**SUBDIVISION**

REZONING STAFF REPORT Date: May 5, 2016

**DEVELOPMENT NAME** Midtown Mobile Subdivision

IRC-Mobile Midtown, LLC

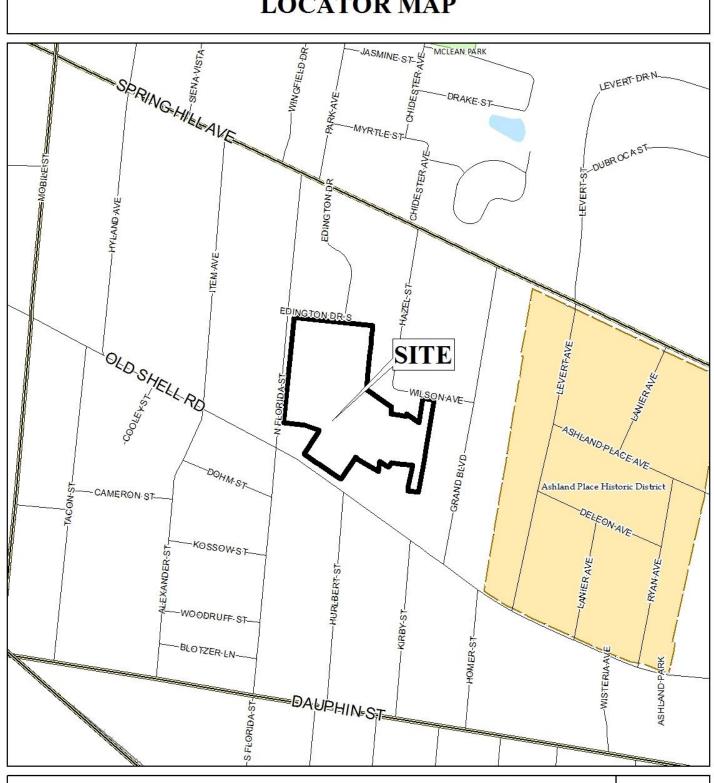
The applicant also submitted an Alternate Site Plan that provides on-street, head-in, angled parking spaces along Florida Street, which are partially on the private property and partially in the right-of-way. No safety lane was provided for vehicles to back out of the spaces and safely enter the traffic lane. The Traffic Engineer has reviewed this proposed alternate design modification and has indicated that any on street parking would have to be parallel spaces, not angled, head in spaces.

### **SITE PLAN**

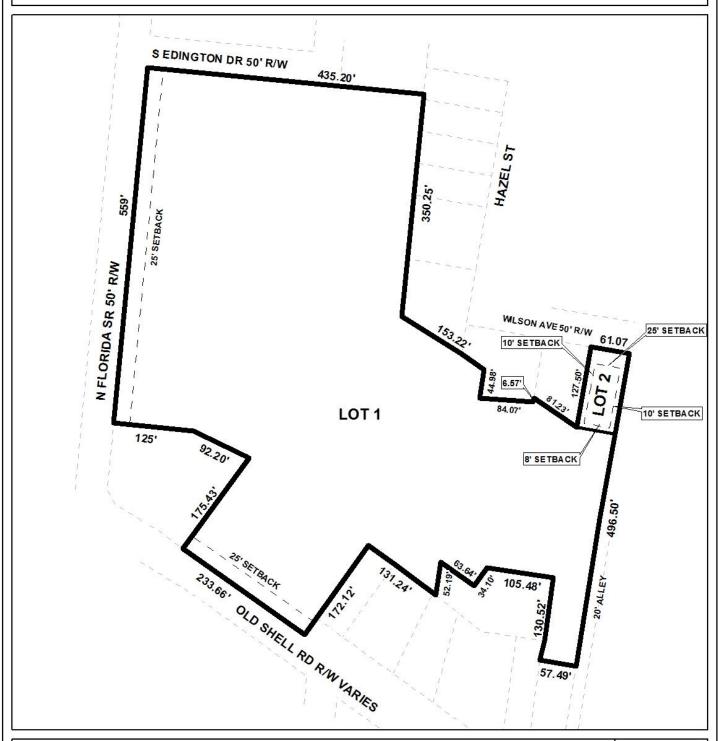
A consultant has been hired to review and rewrite the Zoning Ordinance, Subdivision Regulations, as well as develop a new Major Street Plan Map and General Land Use Plan Map. This will be a 24-30 month process. Until that project is completed and the new documents are adopted, we continue to operate under the existing Zoning Ordinance and Subdivision Regulations. Under the existing Zoning Ordinance requirements for Rezoning, Planned Unit Development approval, and B-2 development standards and requirements, most elements of the proposal comply with the existing regulations. However, there appear to be some issues with the

main parking lot with regard to stall depths in some areas that do not comply with the parking standards.

The site plan does not correspond with the principles, guidelines, and intent of the Map for Mobile, therefore the following items should be addressed:

- 1) Reorientation of Shops B to front Old Shell Road
- 2) Elimination of the drive-thru, including removal of the rear drive, on Shops 1A to provide a more substantial buffer for the adjacent residential properties
- 3) On-site parking to meet the minimum requirements for aisle and stall sizes
- 4) Any on-street parking to be changed to parallel spaces, as required by the Traffic Engineer.

Revised site plan to be submitted by 12:00 pm, May 13, 2016.
